Access Compliance Report

Public Rights-of-Way

(Curb Ramps)

Intersection ID: 7739	Main Street: HIDDEN_VALLEY_RD	Cross Street: YUMA_ST	Location: NE
ADA ID: AAE3EF0672A9	Ramp Type: BlendTrans1	Initial Pass/Fail: Pass	Overall Compliance: No
Severity Score: 2.75			
Codes/Mitigation Info/Possible Solution		Field Measurements/Component Compliance

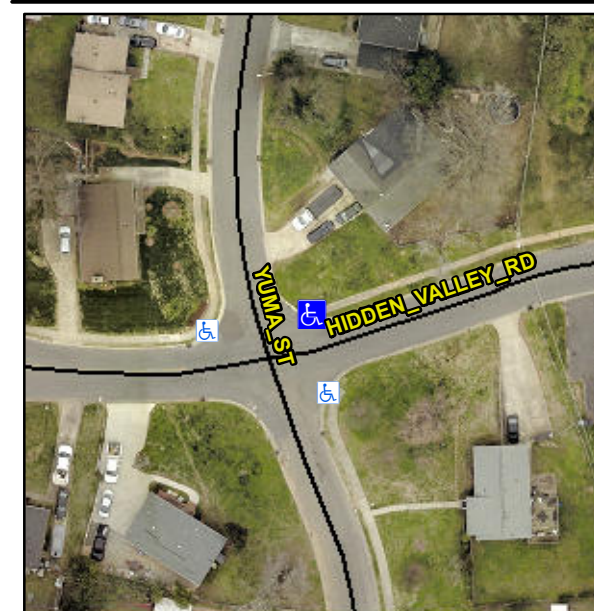
Not Found, R304.5.3, R304.2.1, R305.1.4

Compliance	Description	Data	Compliance	Description	Data
N/A	Ramp Length (in)	31.0	Yes	BlendTrans Slope (%)	0.6
Yes	Ramp Width (in)	49.0	No	BlendTrans XSlope (%)	4.0
N/A	Flare Type LT	Sloped	N/A	Flare Type RT	Sloped
N/A	Flare Slope LT (%)	8.6	N/A	Flare Slope RT (%)	2.2
N/A	Flare Traversable LT?	No	N/A	Flare Traversable RT?	No
No	Landing Length (in)	36.0	Yes	DWS Provided?	Yes
Yes	Landing Width (in)	48.0	Yes	DWS Contrast?	Yes
Yes	Landing Slope (%)	0.6	Yes	DWS Length (in)	24.0
No	Landing X Slope (%)	5.2	No	DWS Full Width?	No
N/A	Landing Curb? (Y/N)	No	Yes	DWS Offset (in)	1.0
N/A	Shared Landing?	No			
Yes	Gutter Ponding?	No	Yes	Gutter Slope (%)	2.6
Yes	Gutter Lip Ht (in)	0.0	No	Gutter X Slope (%)	6.5
N/A	Painted X Walk1?	No	N/A	Painted X Walk2?	No
	X Walk 1 Direction	To W		X Walk 2 Direction	To S
	X Walk 1 Width (in)	N/A		X Walk 2 Width (in)	N/A
	X Walk 1 Slope (%)	7.9		X Walk 2 Slope (%)	5.3
	X Walk 1 X Slope (%)	0.1		X Walk 2 X Slope (%)	7.4

N/A	Ramp inside XWalk1?	N/A	N/A	Ramp inside XWalk2?	N/A
	Road Slope (%)	7.3		Clear Space?	Yes
	Road X Slope (%)	6.8	N/A	Clear Space to XWalk (in)	N/A
Yes	Any Obstructions?	No	Yes	Storm Grate/Utility Hazard?	No
	Obstruction Type			Storm Grate/Utility Type	
		N/A			N/A
			Yes	Surface Condition? (G/P)	Good
			No	Curb Slope (%)	16.9

Remove & Replace Curb Ramp With Two New Directional Ramps or Equivalent. Remove & Replace Gutter.
